SERVICE BULLETIN

No. 319

Piper Aircraft Corporation
"FAA DOA EA-1 Approved"

Exhaust System Inspection and Modification

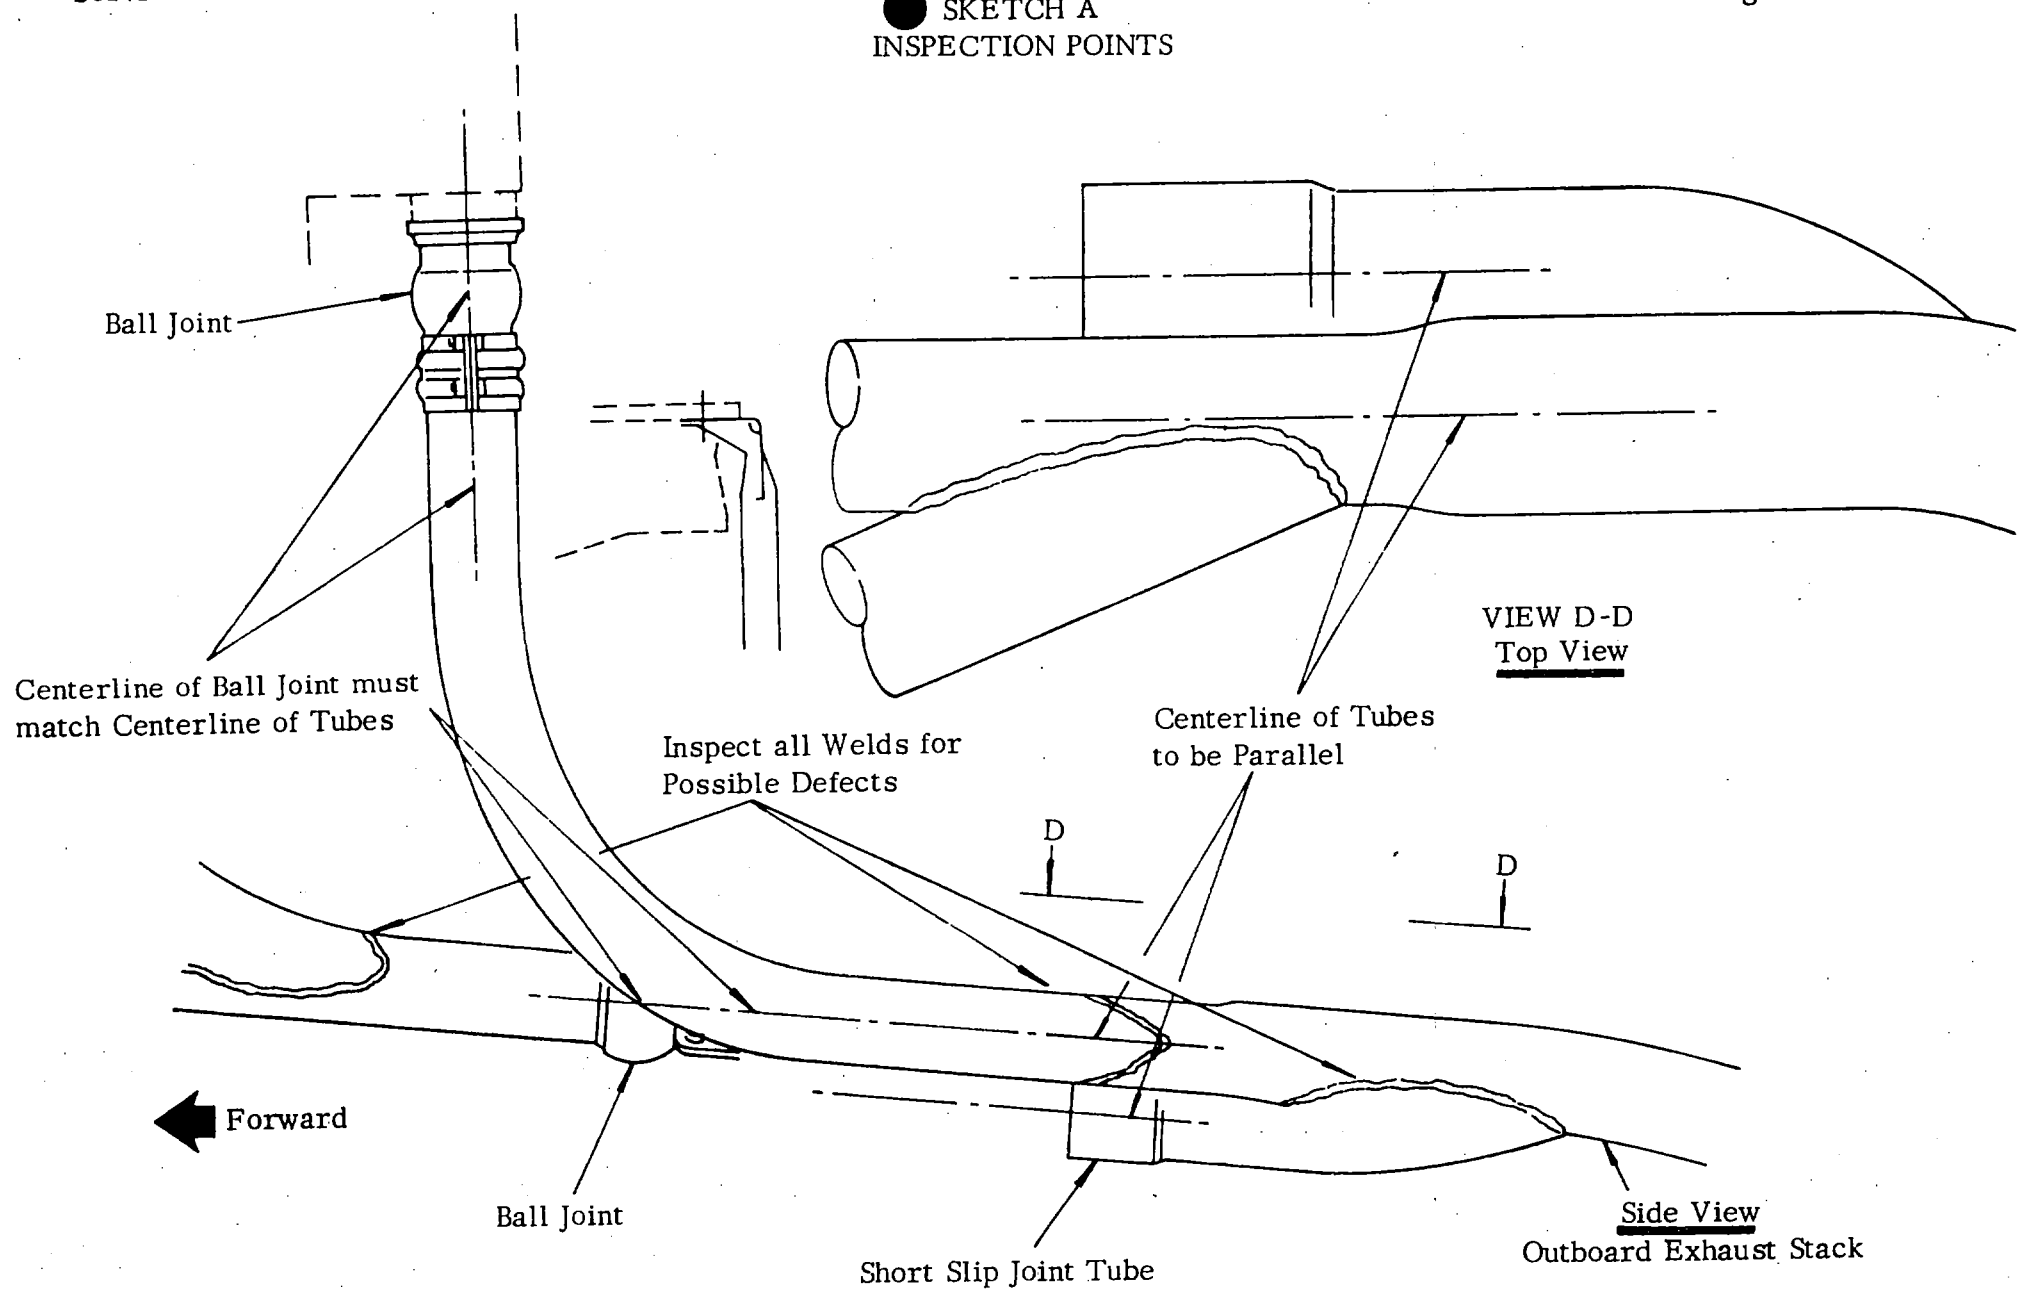
7. Align the ball joint center line with the center line of the mating tube, forward and aft of the ball joint as shown in Sketch B, Figure 1. Ascertain that the crossover tube is properly positioned in the slip joints by checking the location of the previously made reference marks. Retighten the exhaust system.

9. Adjust the clamp at the end of the support bracket to securely hold the tube, refer to Sketch B, Section B-B.

1. The crossover tube must be free to move at both slip joints prior to clamping.
2. There must be a minimum clearance of 1-1/4 inches between the tailpipe and the firewall chute, as shown in Sketch B, Section C-C. If this dimension is not obtainable, the system is not set properly and should be readjusted.

● SKETCH C
CROSSOVER SHROUD
INSTALLATION

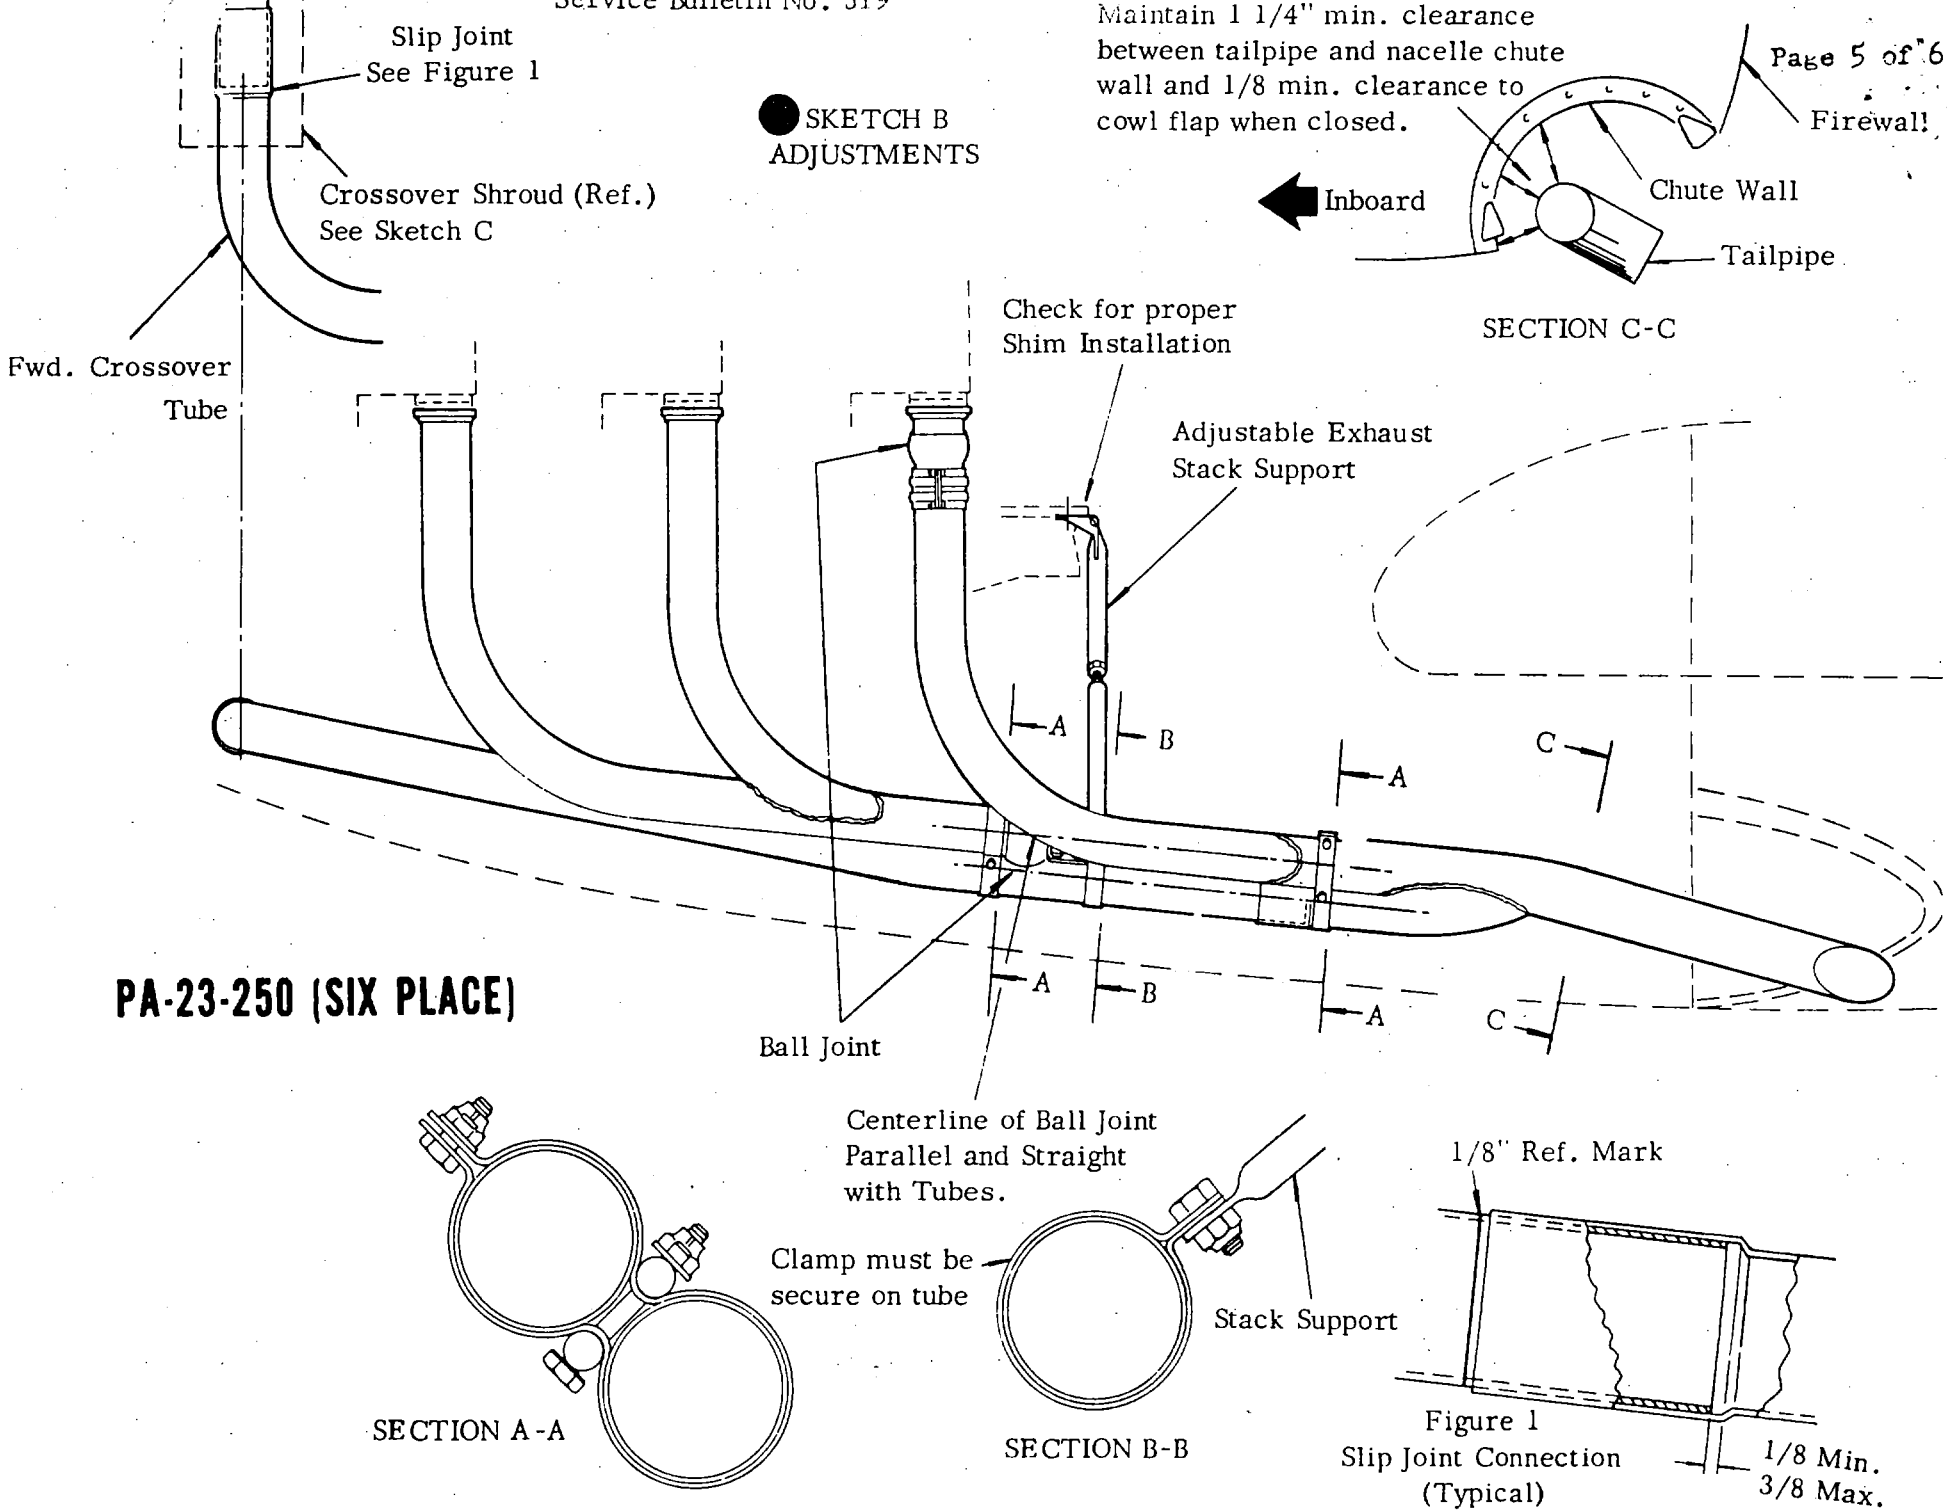
10. Replace existing shroud assembly with the new assembly P/N 33178-02 and 33178-03. Ascertain that 3/8 of an inch clearance is maintained between the end of the take-off assembly and the flange on the new shroud (Refer to Sketch C). The mounting holes of the new assembly should match the existing holes of the clamp assembly. The clamp should be moved to locate the shroud and maintain the end clearance.

11. Ascertain that the take-off assembly is securely fastened to the stack, this may require bending the ears of the take-off assembly down over the stack before tightening the clamp. (Refer to Sketch C.)

A new shroud assembly P/N 33178-02 and 33178-03 must be installed in place of the existing assembly. This must be accomplished on both engines. Refer to instruction below and Sketch C.
